UNITED STATES OF AMERICA
NUCLEAR REGULATORY COMMISSION

PACIFIC GAS AND ELECTRIC COMPANY)

Docket Nos. 50-275-OL
50-323-OL

RESPONSES OF PACIFIC GAS AND ELECTRIC COMPANY
TO INTERROGATORIES FILED BY SAN LUIS OBISPO
MOTHERS FOR PEACE DATED SEPTEMBER 11, 1975

FIG. 1 - DETERMINATION OF SITE FACTOR, \bar{b}

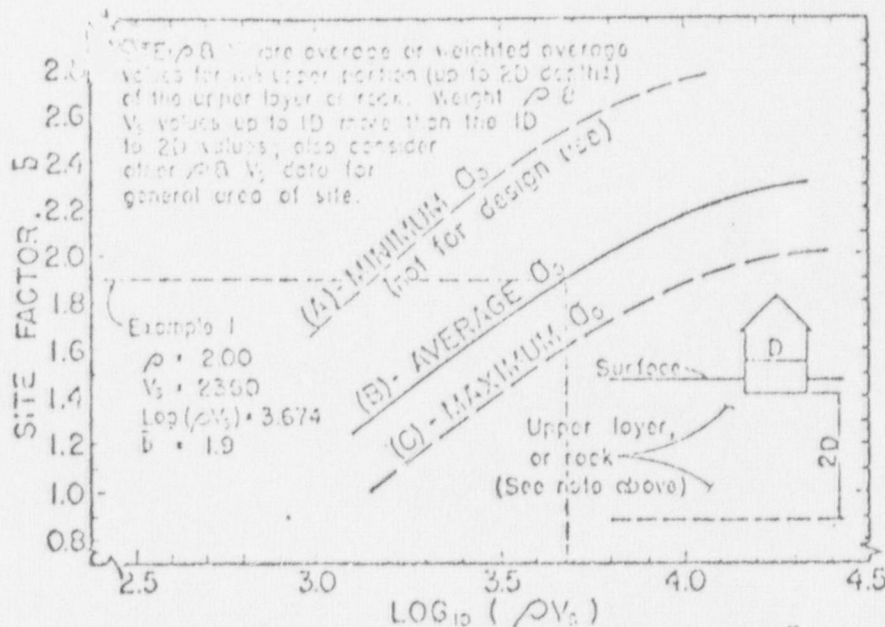
4. Please provide accurate response without errors to question nos. 24 and 25 of J. J. Forster's Interrogatories, 6-27-75

In our response, dated June 27, 1975, to these interrogatories the numerator was inadvertently omitted in the right-hand side of the second equation given. For corrected response see attachment dated 9/26/75.

$$\log a_0 = -(\bar{b} + 3) + 0.81M - 0.027M^2$$

$$a = \frac{a_0}{1 + \left(\frac{\Delta}{h}\right)^2}$$

\bar{b} = site factor from Figure 1
